STAFF REPORT
COMMUNITY DEVELOPMENT DEPARTMENT

HEARING DATE: 5/6/2021
 TO: Planning & Zoning Commission
 FROM: Alan Tiefenbach
 208-884-5533
 Bruce Freckleton, Development Services Manager
 208-887-2211
 SUBJECT: H-2021-0018
 Jump Creek North Fourplex CUP

Conditional Use Permit (CUP) to allow 7 fourplexes (28 units) on 2.2 acres in the R-15 zone.

D. Landscape Plan (date: 1/31/2020)

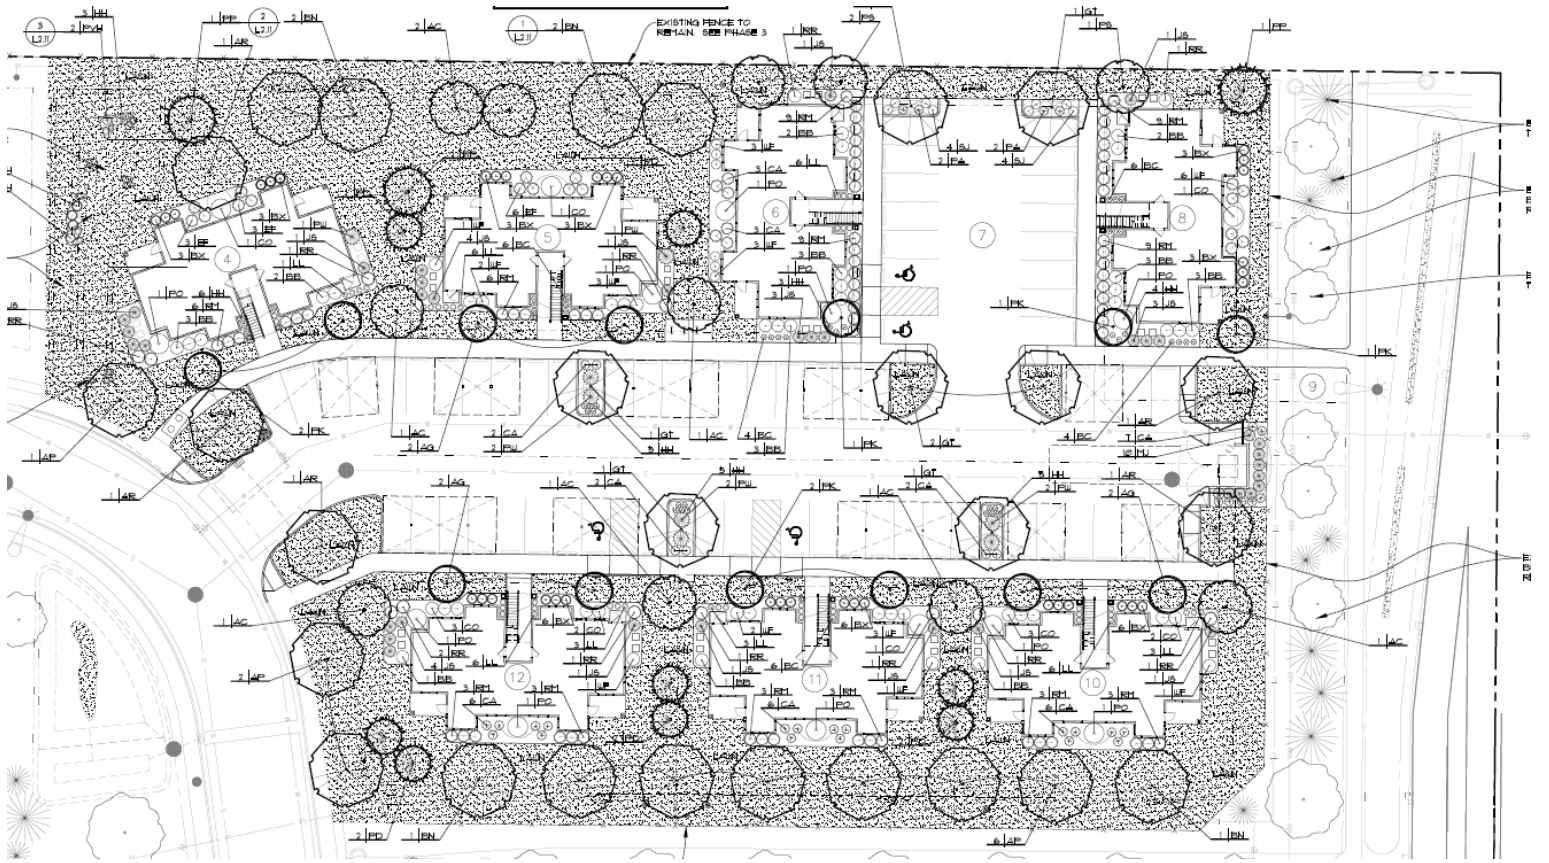
The landscape plan depicts 6' wide sidewalks along both sides of the access road and parking lots.

UDC 11-3B-8 requires a five-foot minimum landscape buffer adjacent to parking, loading, or other paved vehicular use areas, with no grouping of parking spaces to exceed 12 in a row without a parking island. The parking aisles and lot appears to meet all requirements, including

minimum amount of landscape plantings. The foundations of all fourplexes are landscaped with at least 3' of landscaping along their foundations as required by the Specific Use Standards listed in 11-4-3-27.

The landscape plan indicates there is existing fencing along the northern perimeter that is proposed to be retained. No other fencing is shown with this development. Any fencing should comply with UDC 11-3A-7.

3. The site plan and landscape plan submitted with the Certificate of Zoning Compliance application shall be revised to depict a management office, maintenance storage area and a directory map of the development at an entrance or convenient location for those entering the development as set forth in UDC 11-4-3-27B.7:

- b. The site plan/landscape plan shall indicate the location of the central mailbox.
4. At the time of Certificate of Zoning Compliance (CZC), the Developer/Owner shall submit a common open space exhibit that meets the requirements of UDC 11-4-3-27-C.

E. Floor Plans (date: 12/14/2020)

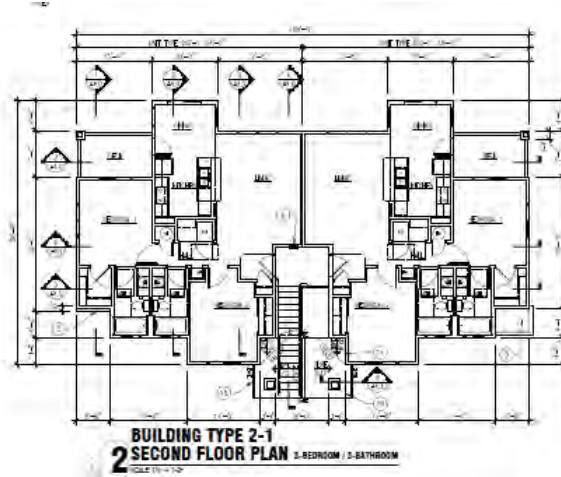
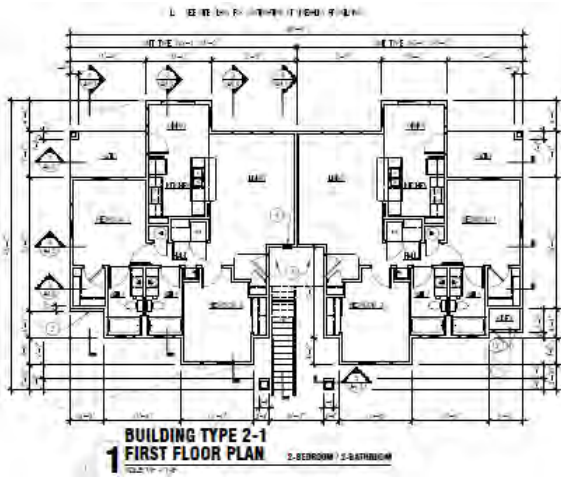
The site plan and landscape plan indicate the minimum 10’ setback is met along all perimeter property lines. The submitted floorplans indicate patios and decks on the units that are slightly less than the requirement. The applicant will need to submit floor plans at the time of CZC that demonstrate this requirement is met.

7. At the time of Certificate of Zoning Compliance (CZC), the Developer/Owner shall submit floorplans which comply with the private open space requirements of 11-4-3-27B.
